# Sheringham Shoal and Dudgeon Offshore Wind Farm Extension Projects

Apportioning and HRA Updates Technical Note  
(Revision E) (Tracked)

Document Reference: 13.3.1

Title: Figure 1 Overlap of SEP 10km buffer (in 1km increments) with Greater Wash SPA and area outside Red-throated Diver MCA (from Lawson et al., 2016)

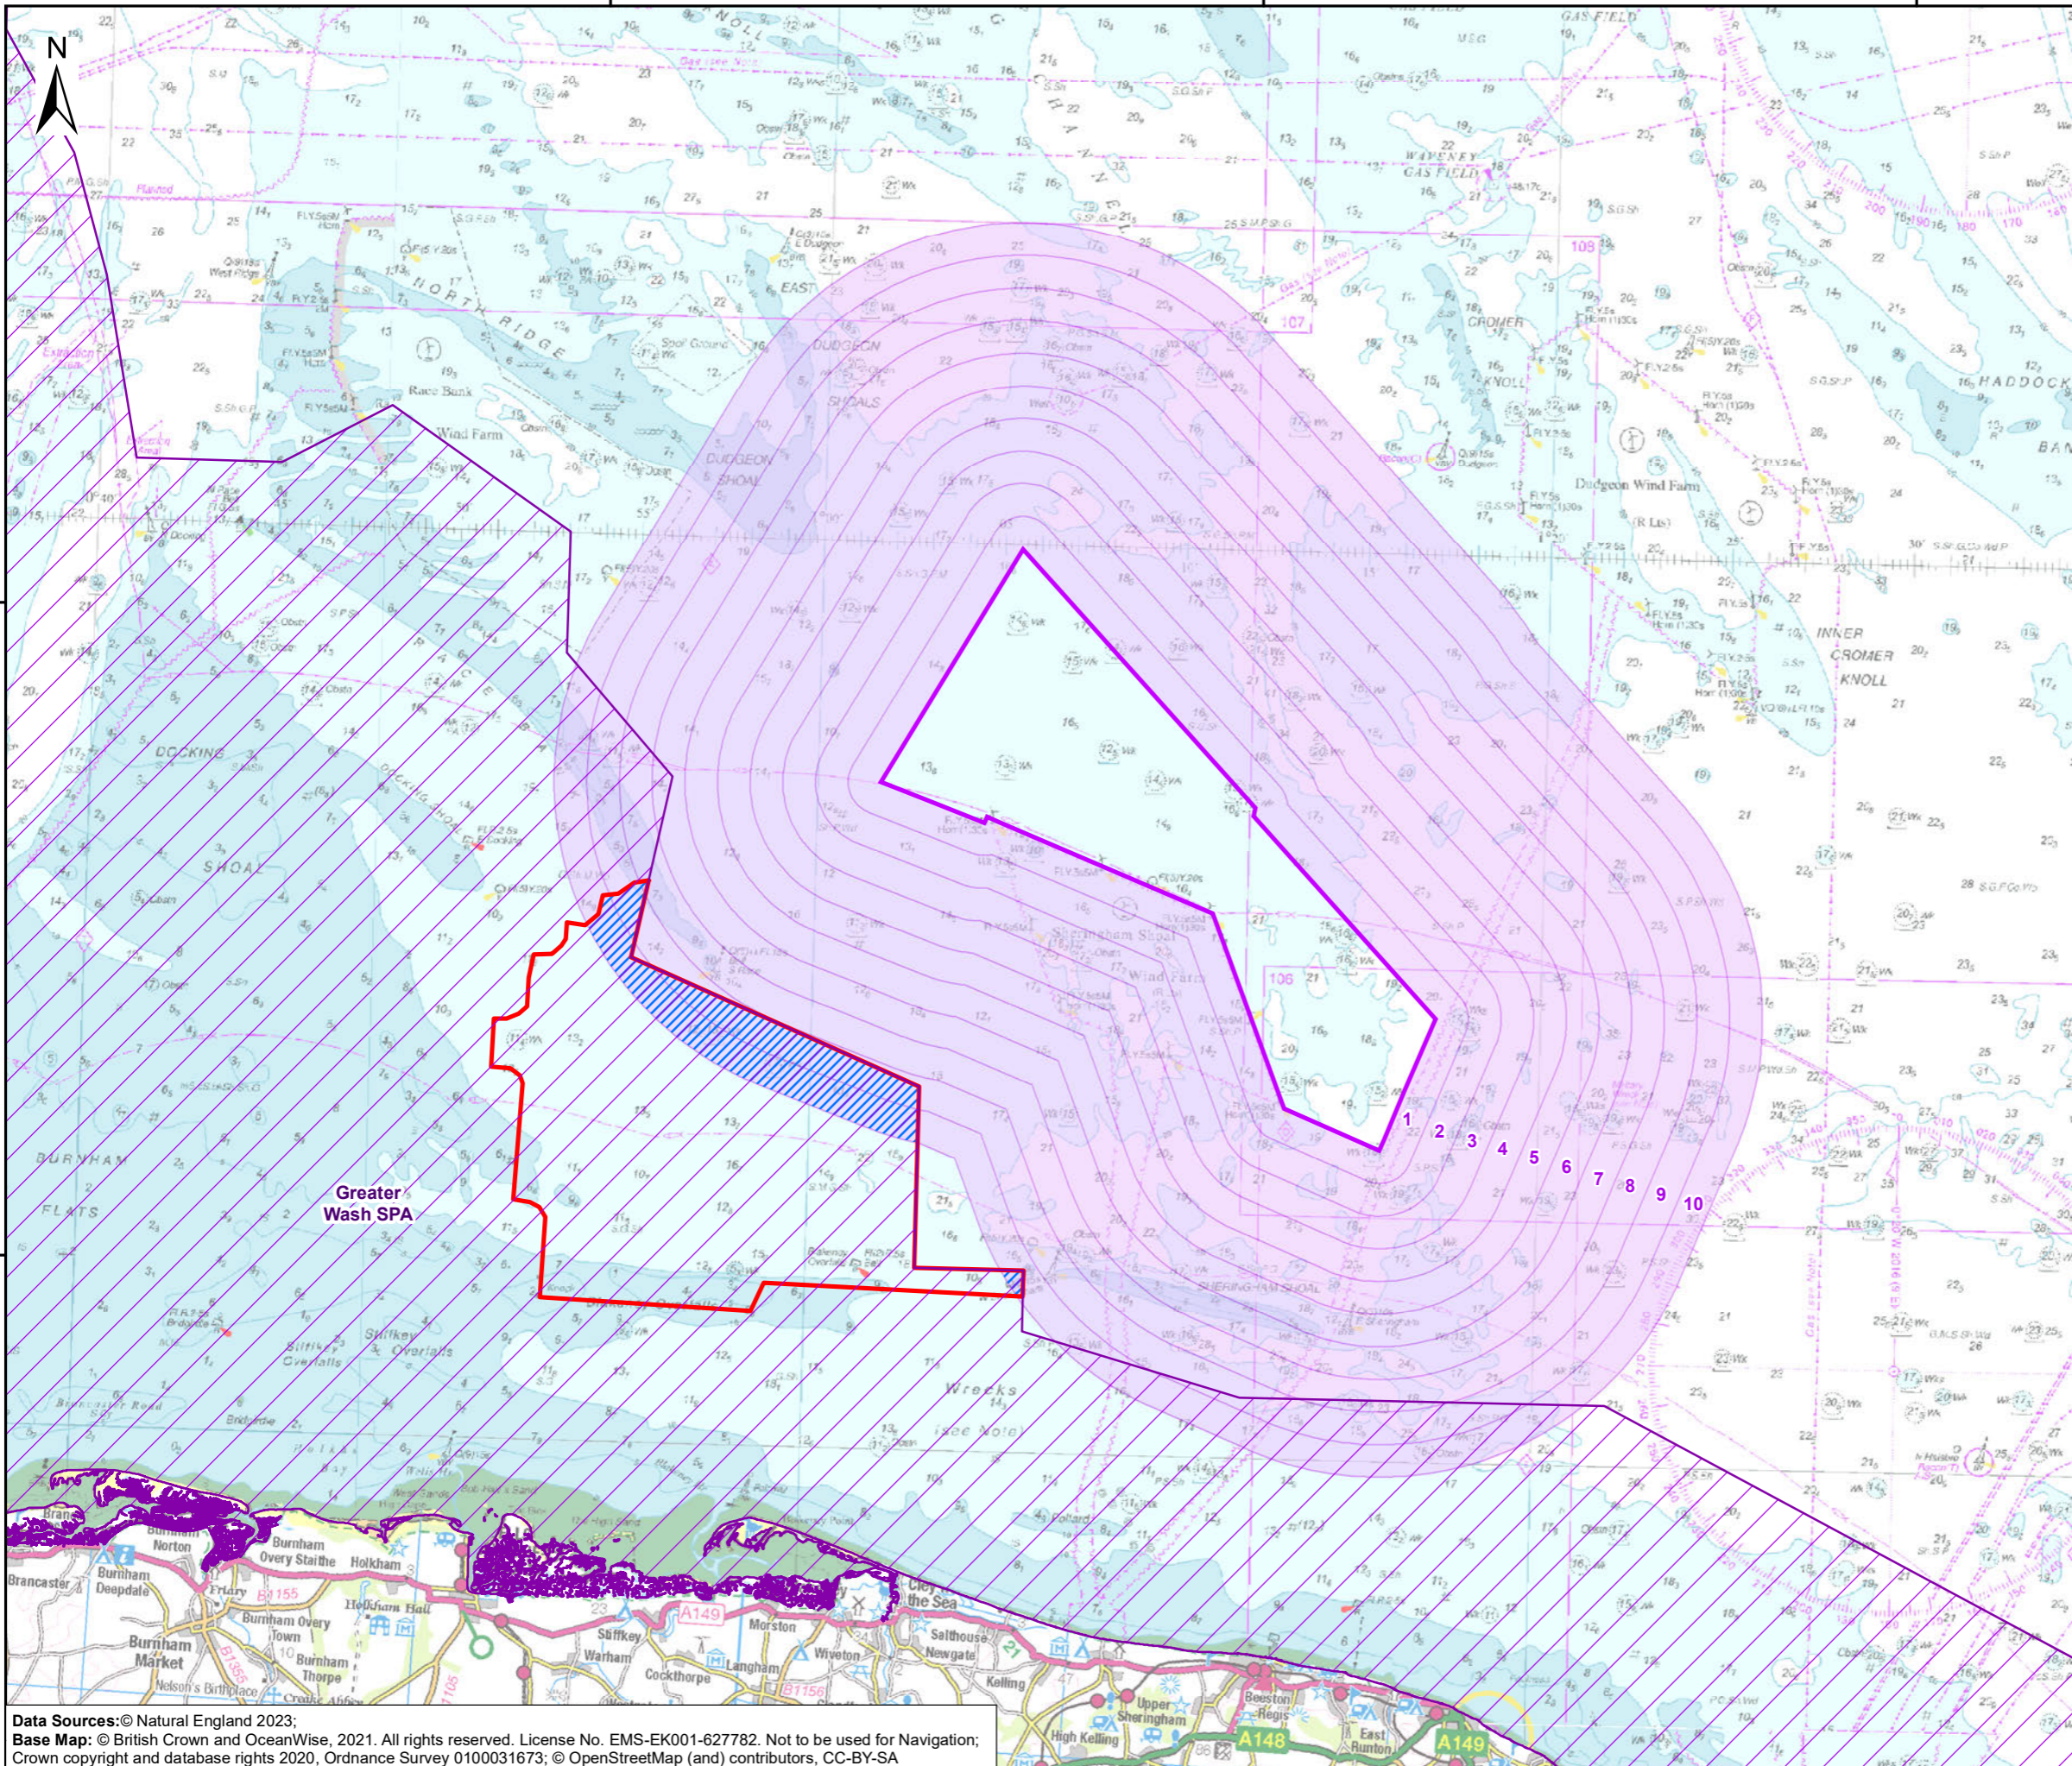
17	11. GW SPA RTD	91	<p>A) We recognise that parts of the Greater Wash SPA fall outside the area identified by Maximum Curvature Analysis (MCA) as being the most suitable parts of the SPA for RTD. MCA was used to identifying the areas important to each relevant species, a composite of which was then used to determine the boundary of the SPA. However, whilst it is reasonable to say that these areas are less important to RTD than other parts of the site, we do not consider that the area should be entirely excluded from estimates of the displacement area for this species. We highlight that RTD were recorded in this area during the classification surveys, and furthermore, that recent digital aerial surveys of the GW SPA conducted in October 2022 show the presence of RTD in this area. outside the RTD MCA. Therefore, Natural England's assessment of potential impacts does include</p>	<p>A) Noted</p> <p>B) Clarification regarding the need for vessels to transit to and from the export cable laying site during installation is provided in <a href="#">Section 14.2.1</a>.</p>

ID	Section of draft document	Paragraph	Natural England comment	Applicant response
			<p>some consideration of the area that falls beyond the MCA line, albeit with the caveats noted above. It is therefore helpful that the Applicant has provided displacement area/SPA % values including as well as excluding this area.</p> <p>B) Natural England note that potential impacts from construction vessels transiting to and from the cable corridors have not been considered within the assessment, presumably due to the fact that the construction port(s) will not be confirmed until nearer the start of construction. However, Natural England consider that due to the fact that use of a port adjacent to either the Greater Wash SPA or Outer Thames is plausible, some further consideration of the possible impacts from construction vessels transiting to and from the ECC should be undertaken.</p>	
18	11. GW SPA RTD	Figures 1 & 2	The legends for Figures 1 and 2 incorrectly show the boundary of the RTD MCA and the area where SEP's buffer zone overlaps the RTD MCA.	The legends for <b>Figure 1</b> and <b>Figure 2</b> have been updated.

~~105.~~106. Updated estimates have also been calculated for the area within the SPA within which displacement could occur, based on Natural England's new displacement rates. Minor changes to the areas used for this calculation have all been used in the updated estimates, based on revised GIS analysis (Appendix 3). Two estimates have been presented; the first uses the same approach as the RIAA [APP-059]. The second uses information presented within the Departmental Brief for GW SPA (Natural England and JNCC, 2016) and which at a meeting on 15 November 2022 the Applicant was recommended by Natural England to investigate further. This method excludes an area of the SPA that is outside of the Maximum Curvature Analysis (MCA) for red-throated diver. The MCA is presented in the Departmental Brief (Natural England and JNCC, 2016) and identifies the areas where significant densities of red-throated diver are likely to be present, based on data presented in Lawson *et al.* (2016). This information contributed to determining the SPA boundary. A section of the GW SPA, which is also within 10km of SEP, lies outside the MCA for red-throated diver (Figure 1), i.e. the section of the SPA

which was designated on the basis of a different qualifying species (little gull) and not on the basis of the distribution of red-throated diver. As this area lies outside the zone designated for red-throated diver within the GW SPA, it is considered reasonable to exclude it from the estimate of the displacement area for this species (see **Figure 1**).

Title: Figure 2 Overlap of SEP 10km buffer not impacted by existing OWFs

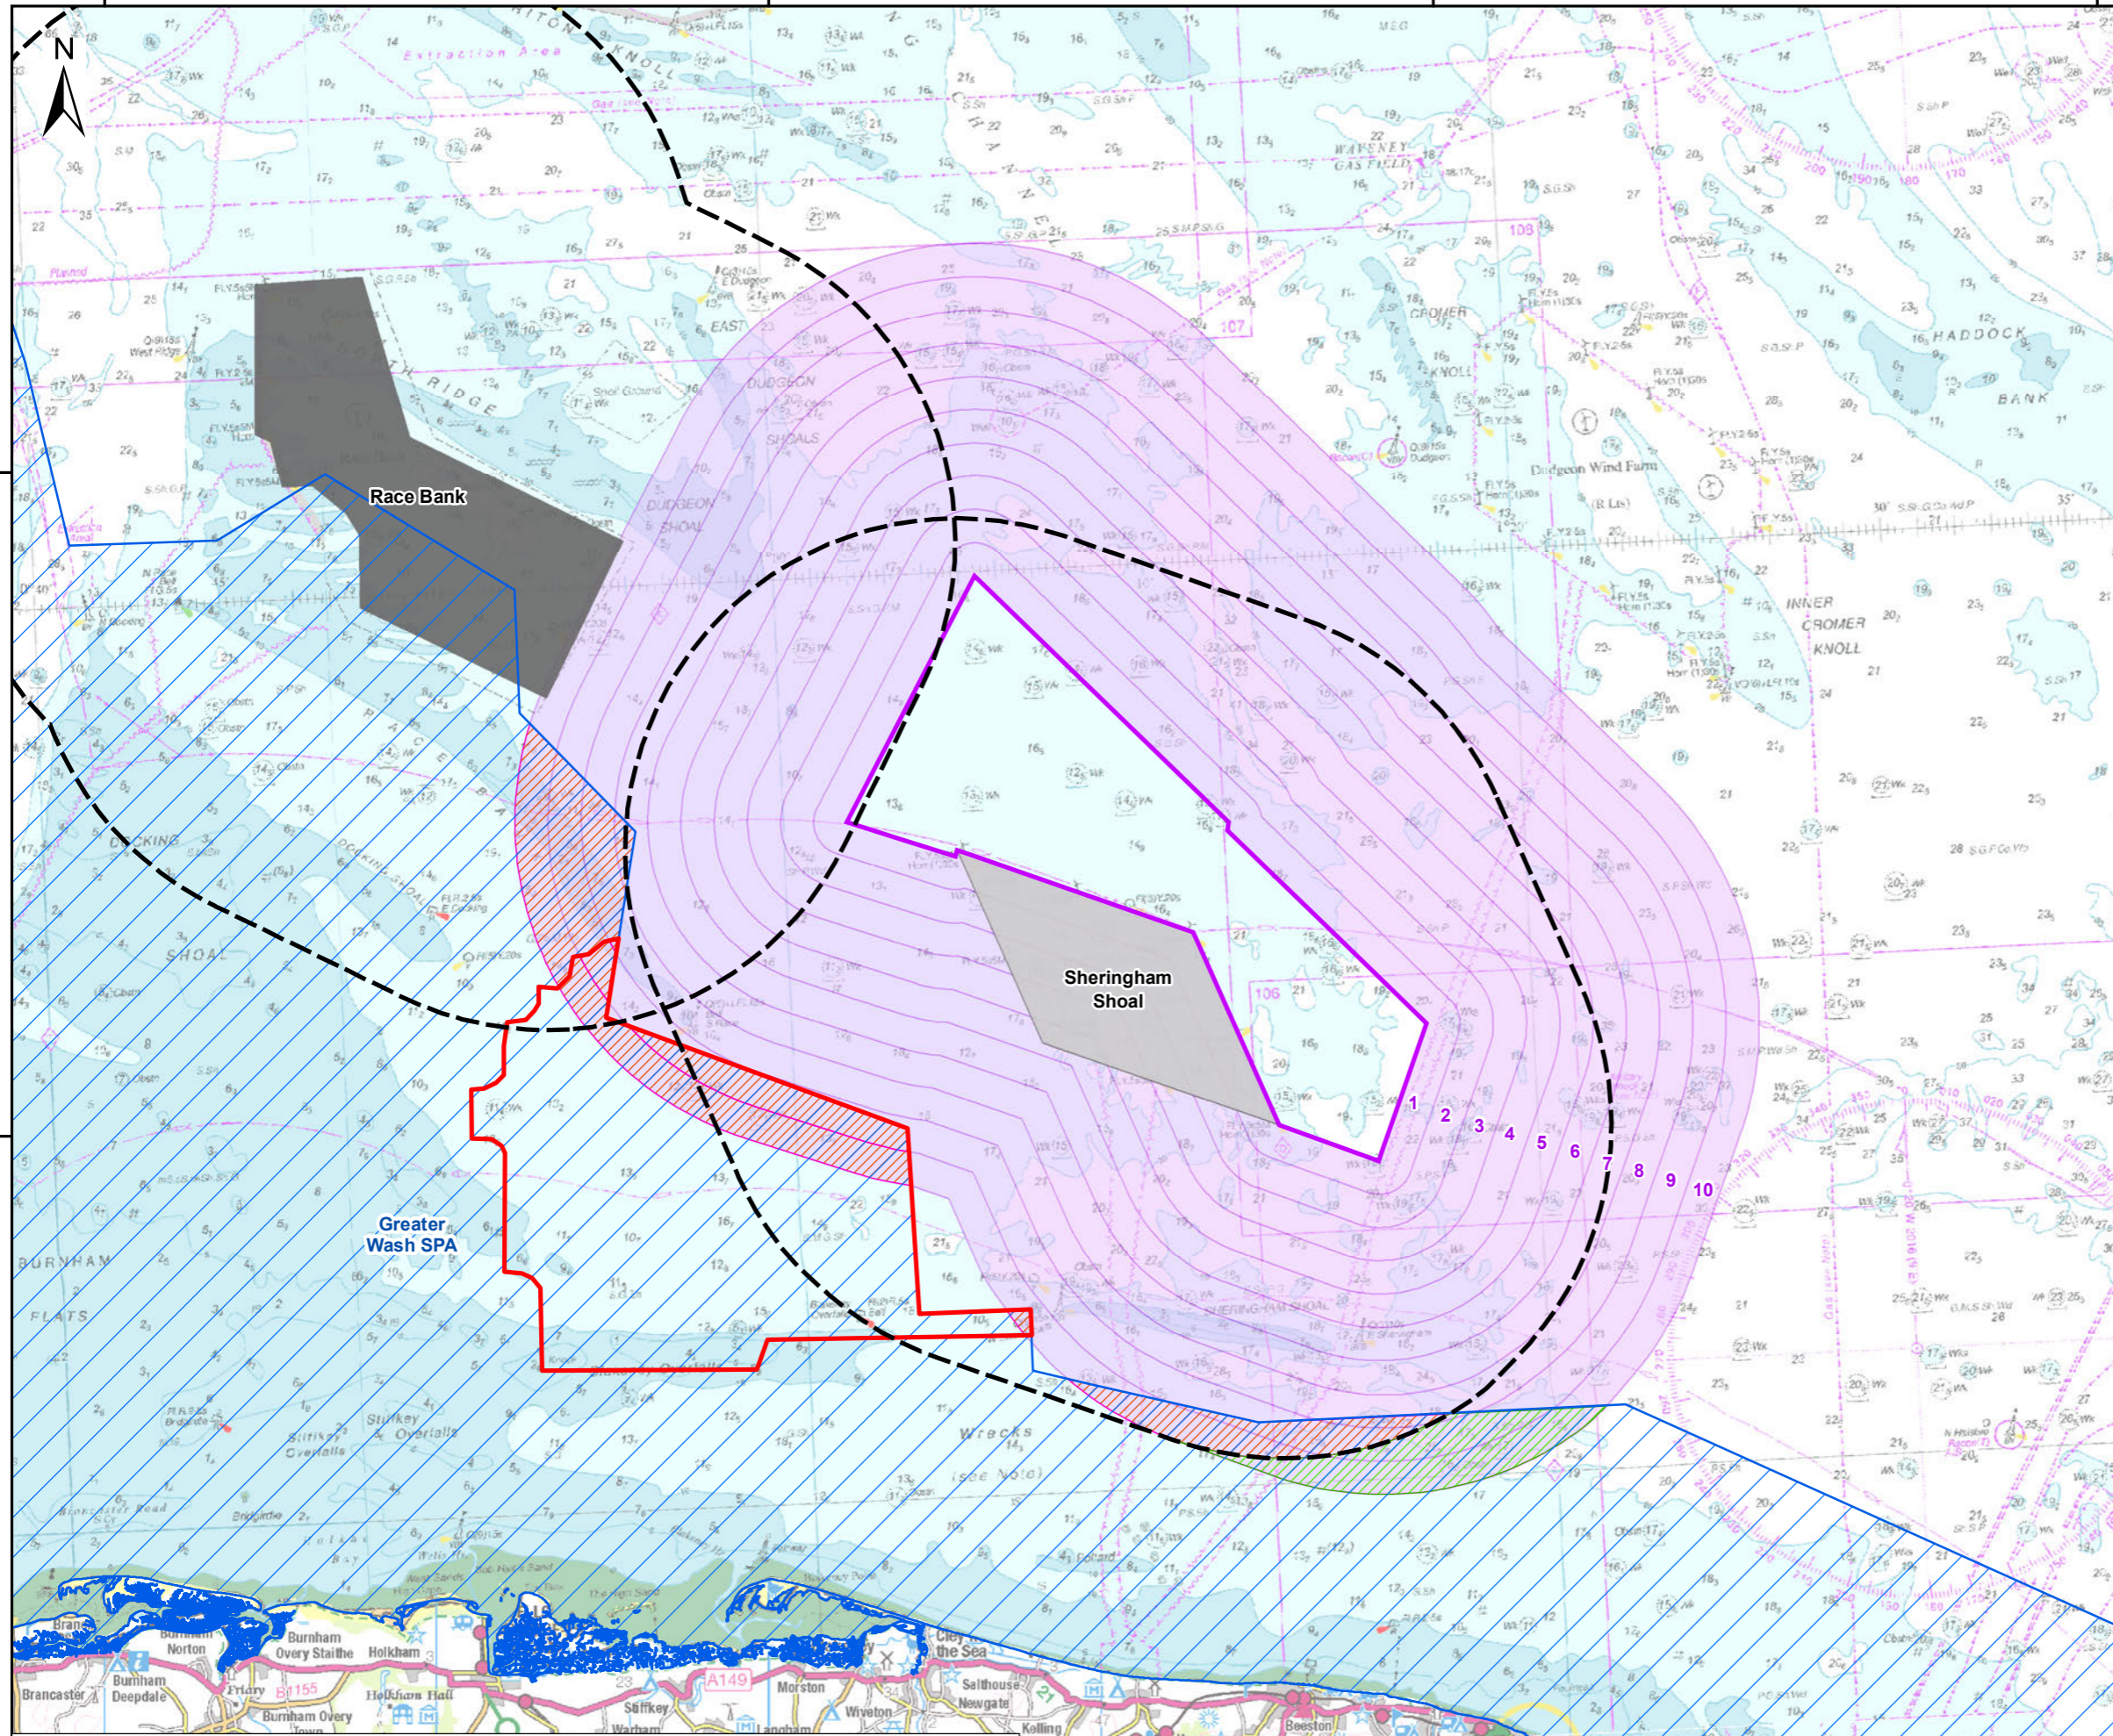
22	11. GW SPA RTD	99	As recognised by the Applicant in the RIAA, excluding areas that overlap existing OWFs from the calculations of area over which displacement could occur as a result of SEP alone does not account for the potential increase in the magnitude of impact in these areas if SEP is closer than the existing OWFs, and therefore this is likely to be an underestimate. Furthermore, even if SEP is further away, it is plausible that it could exert an additional displacement effect. Therefore, Natural England consider that the real project alone impact	The Applicant has updated values in <b>Table 14-3</b> and <b>Table 14-4</b> to account for buffer overlap areas where the effect of SEP would be greater than from existing OWFs. This has slightly increased the effective area of displacement from 0.16% to 0.22% (where all of the SPA boundary is included) and 0.12% to 0.17% (where the area outside of the red-throated diver MCA is excluded).

ID	Section of draft document	Paragraph	Natural England comment	Applicant response
			<p>will lie somewhere within the range of 0.41% - 1.77% for the percentage of the total area of the SPA subject to displacement (and 0.12% - 0.56% for the 'effective area of displacement') based on the SEP buffer zones as presented in tables 11-3 and 11-4.</p>	<p>The Applicant maintains that it is reasonable to exclude areas already impacted by OWFs from the effective area of displacement. If this were not the case (and that Natural England's assertion that SEP could exert an additional displacement effect, even when it is more distant from a given point than existing OWFs was correct) then this would suggest that the shape and/or size of a windfarm array would result in a different level of effect at a given distance from the array boundary. The Applicant is not aware of any evidence for such a difference, and Natural England's recommended approach for calculating displacement effect does not take this into account.</p>

i.e. within the red-throated diver MCA and outside areas within 10km of existing windfarms, is 6.03km<sup>2</sup> or 0.17% of GW SPA; the net impacted area is shown hatched green on **Figure 2**. As DEP is more than 10km from the Greater Wash SPA, no effects are predicted for this OWF.
